**Subject: Bid Package #2**  
Abbott Middle School HVAC Replcmt-DSA 01-119556  
George Hall Elementary School HVAC Replcmt-DSA 01 119523  
Laurel Elementary School HVAC Replcmt DSA 01-119551  
San Mateo - Foster City School District

### **ADDENDUM NO. 3**

San Mateo-Foster City School District  
HVAC Replacement Scope,  
Abbott MS DSA 01-119556  
George Hall ES DSA 01-119523  
Laurel ES DSA 01-119551

AD3  
E0.1

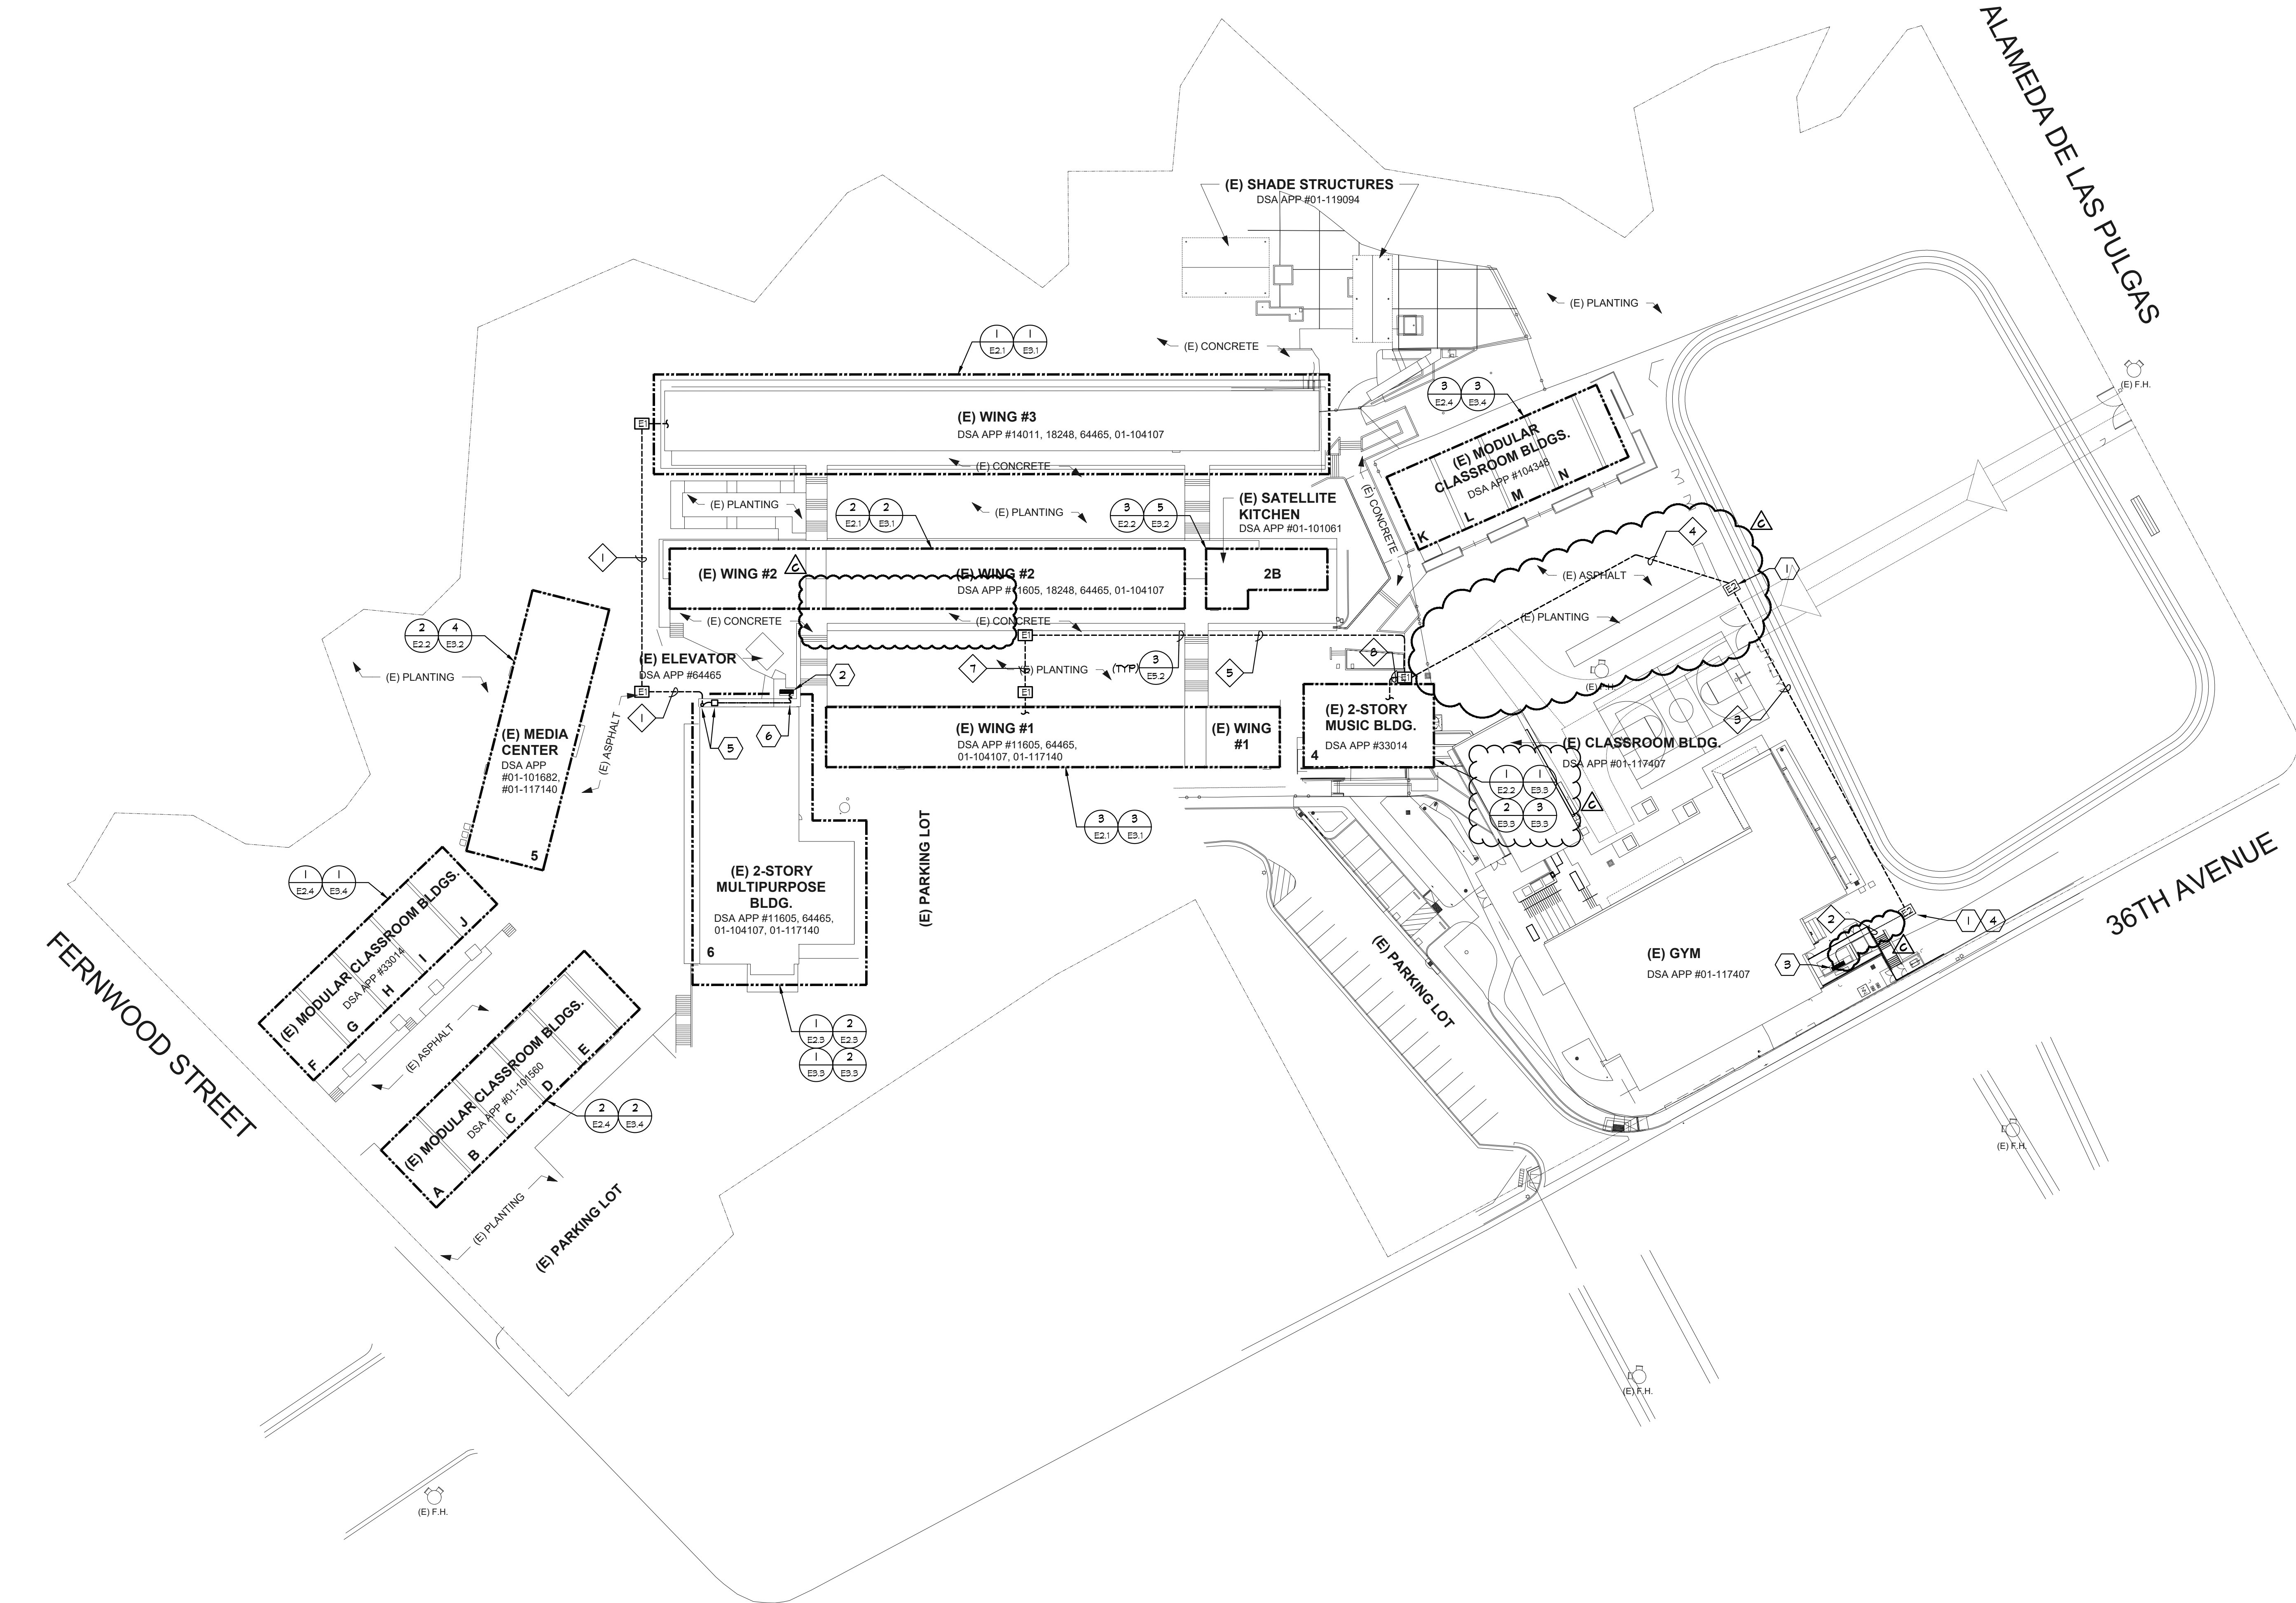
ITEM NO. 3.23:      DRAWING SHEET E0.1 Electrical Cover Sheet

Revise:      Wiring & Conduit Run Symbols per attached AD3-E0.1

SHEET # AD3  
E1.1

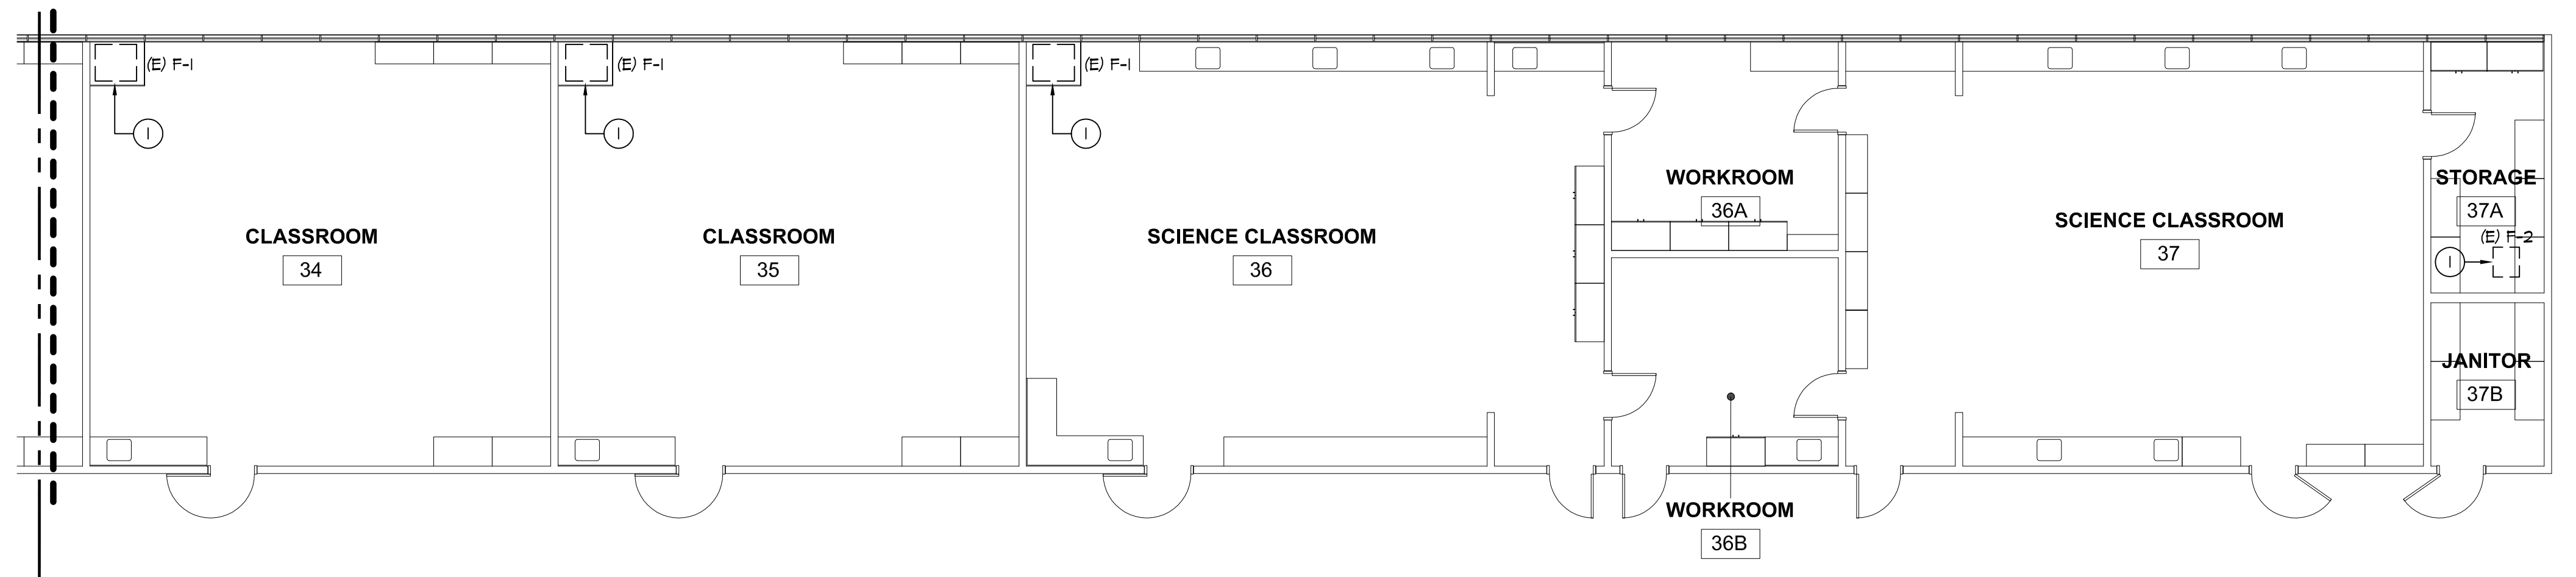
ITEM NO. 3.24:      DRAWING SHEET E1.1 Electrical Site Plan

Revise:      General Note #2 per attached Sheet AD3-E1.1.

Revise:      Conduit schedule #2, #3, #4 and #5 per attached AD3-E1.1.

Remove:      Conduit schedule #6 per attached AD3-E1.1.

Revise:      Conduit routing on the plan per attached AD3-E1.1.

DATE  
12/22/2021  
JOB #  
2021005.06  
SHEET #  
AD3  
E3.1

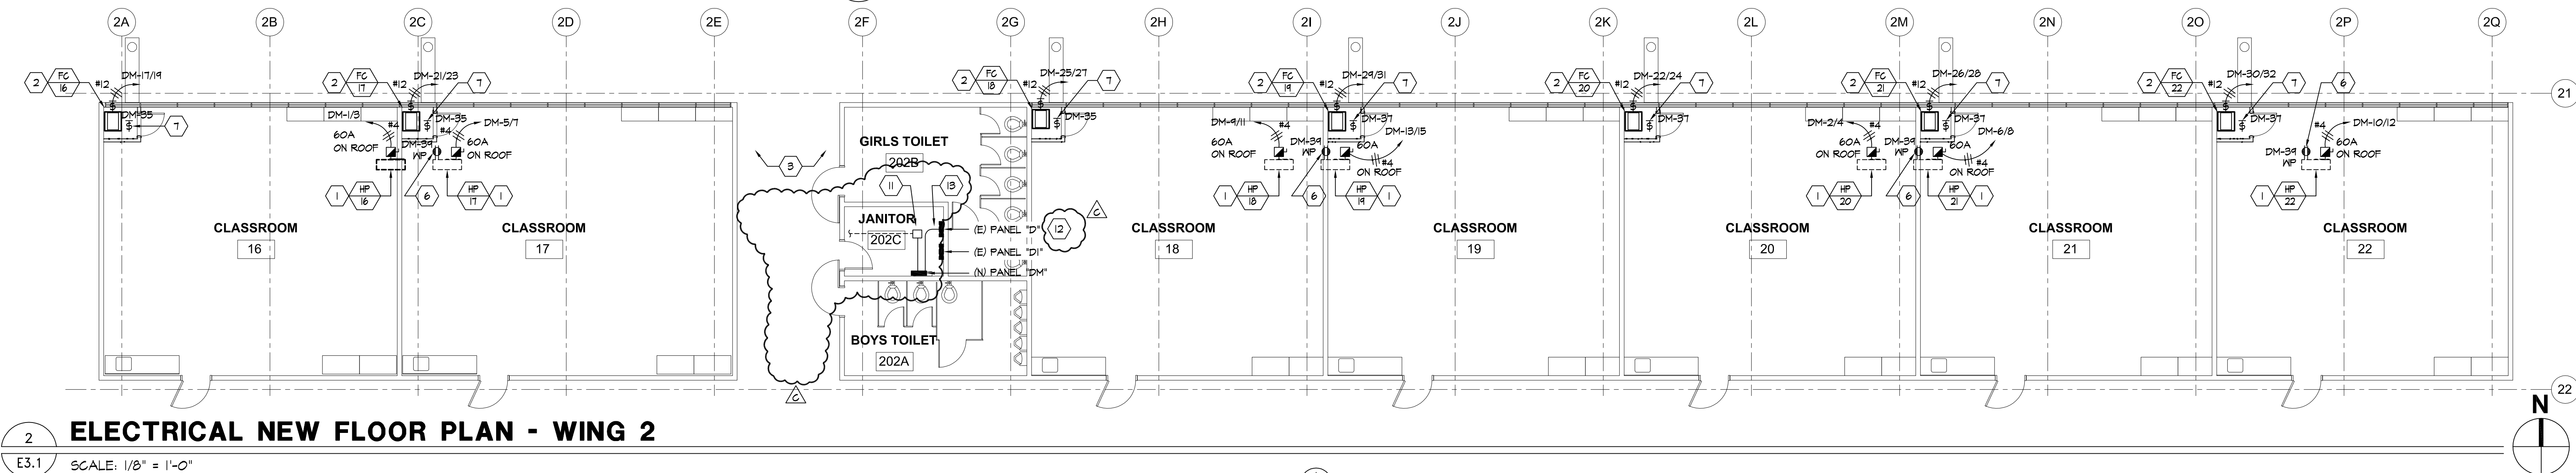
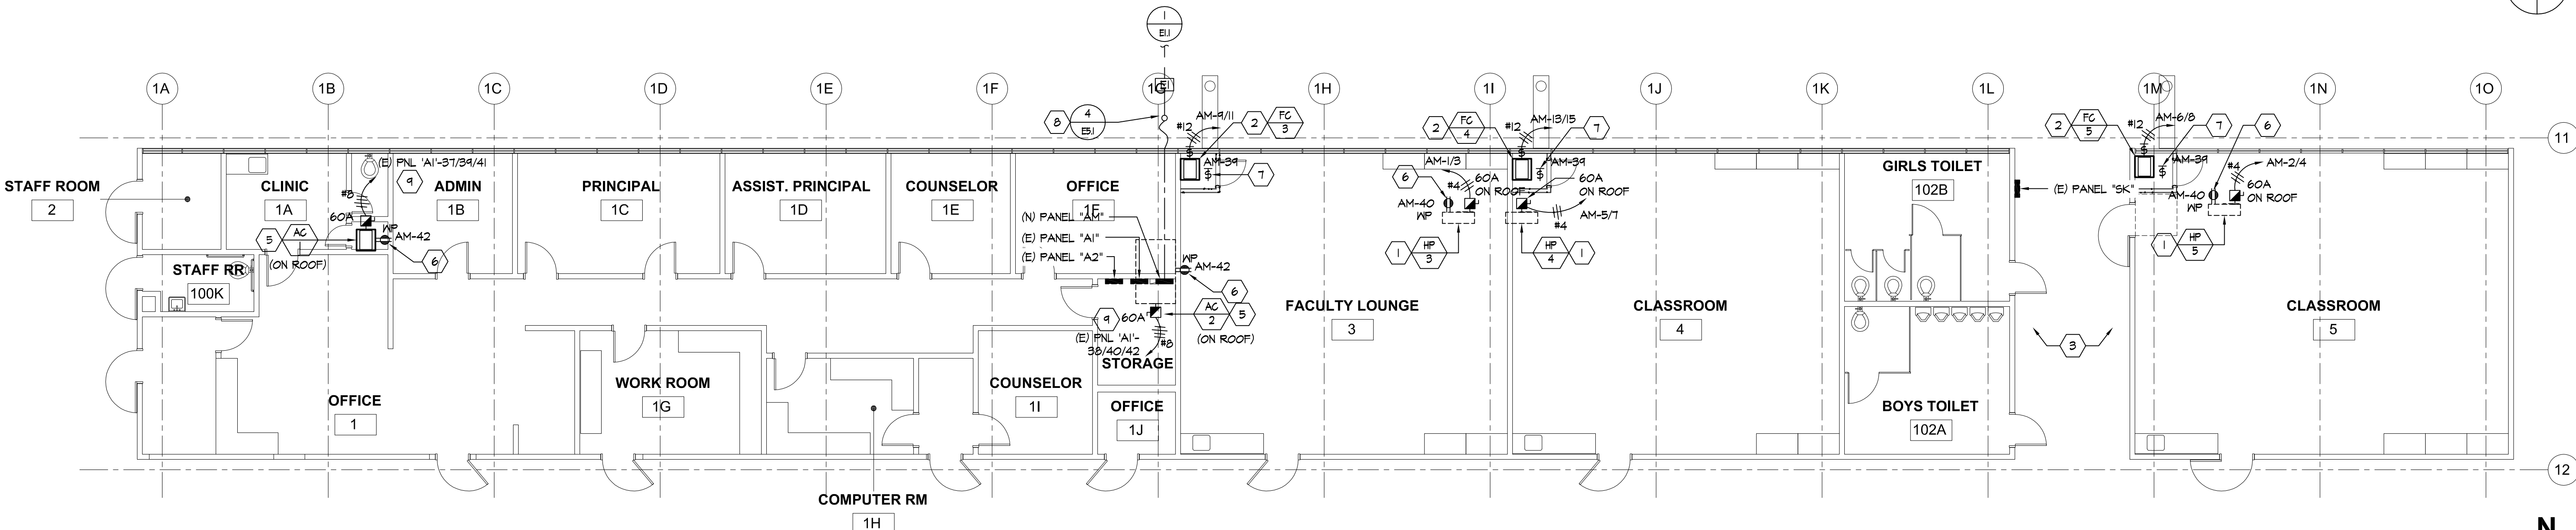
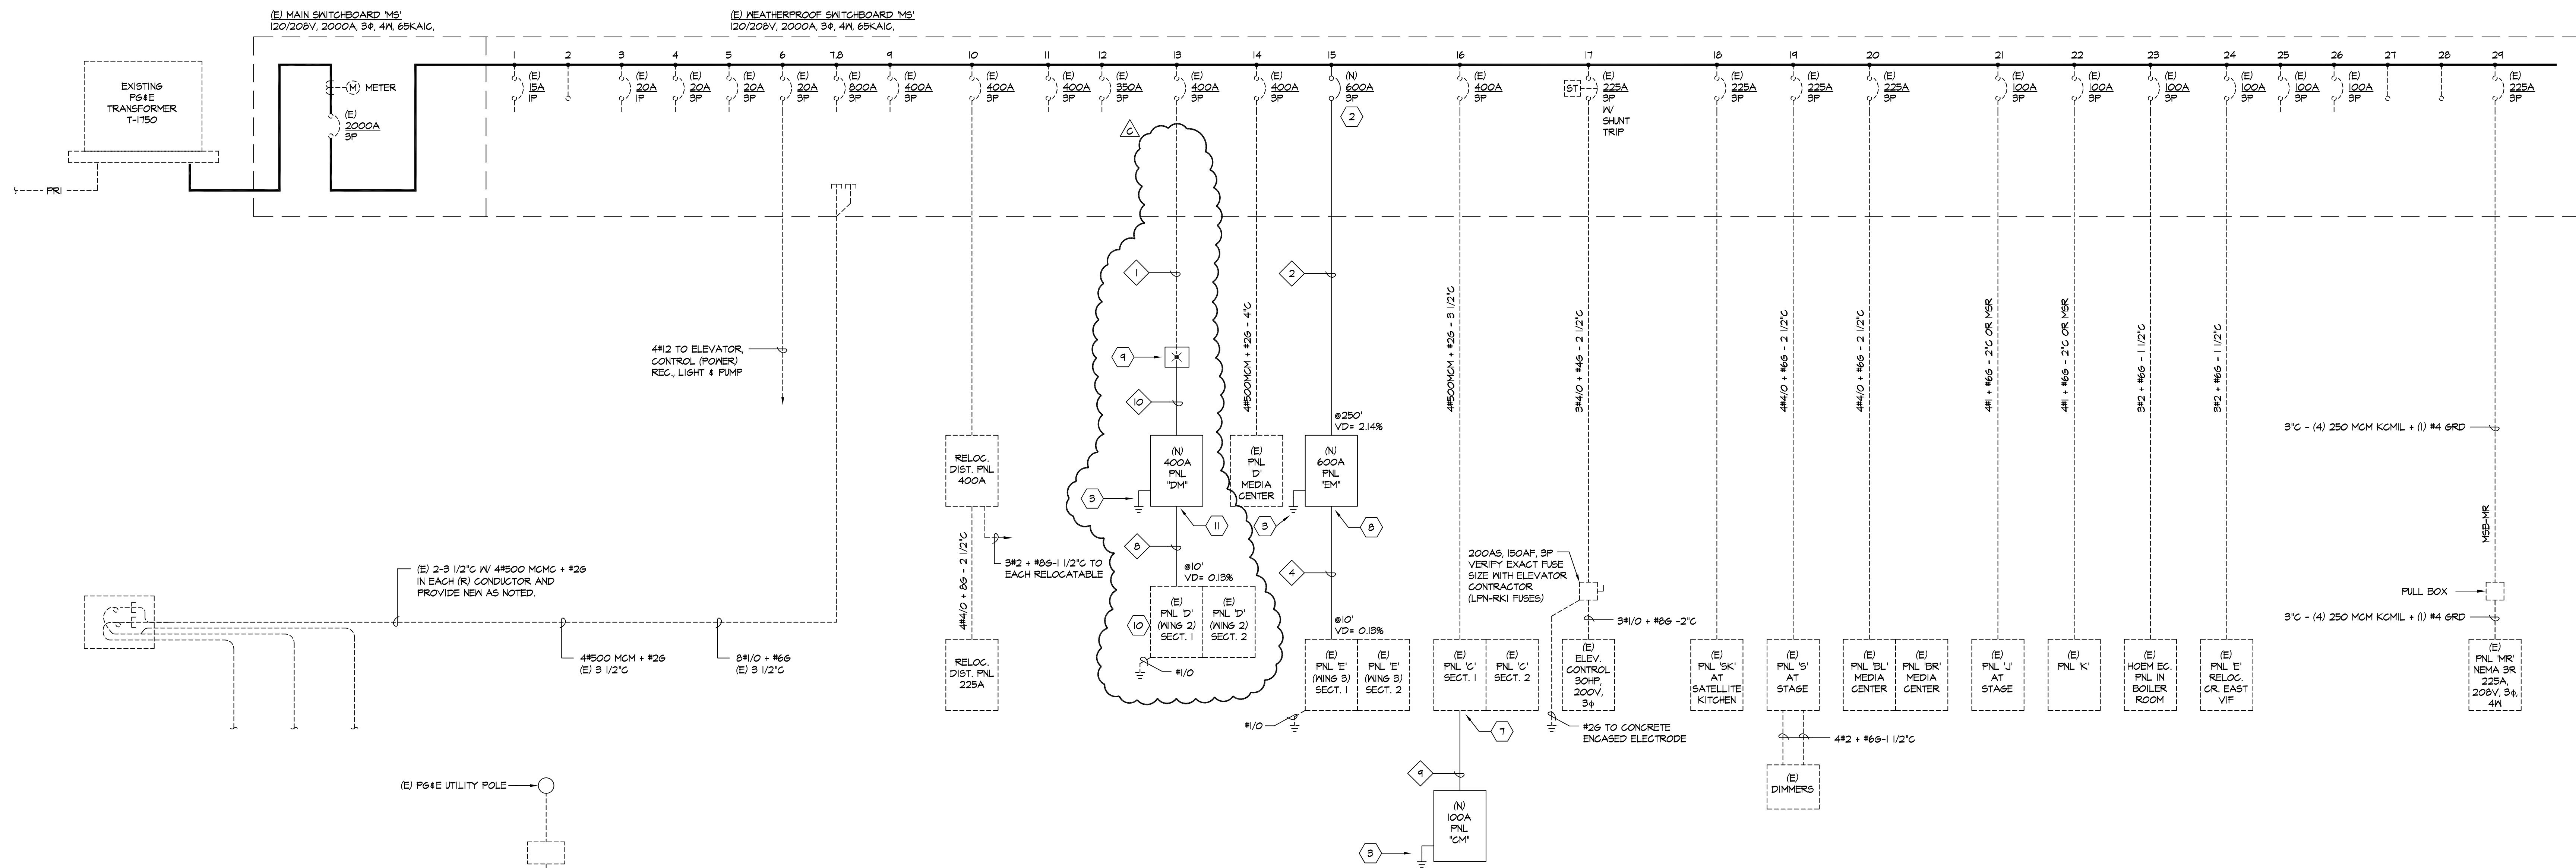
ITEM NO. 3.26:      DRAWING SHEET E3.1 Electrical New Floor Plan Wings 1, 2, 3

Add:      Sheet Note #11, #12, #13 per attached AD3-E3.1.

Add:      Sheet Note #11, #12, #13 tag on plan per attached Sheet AD3-E3.1.
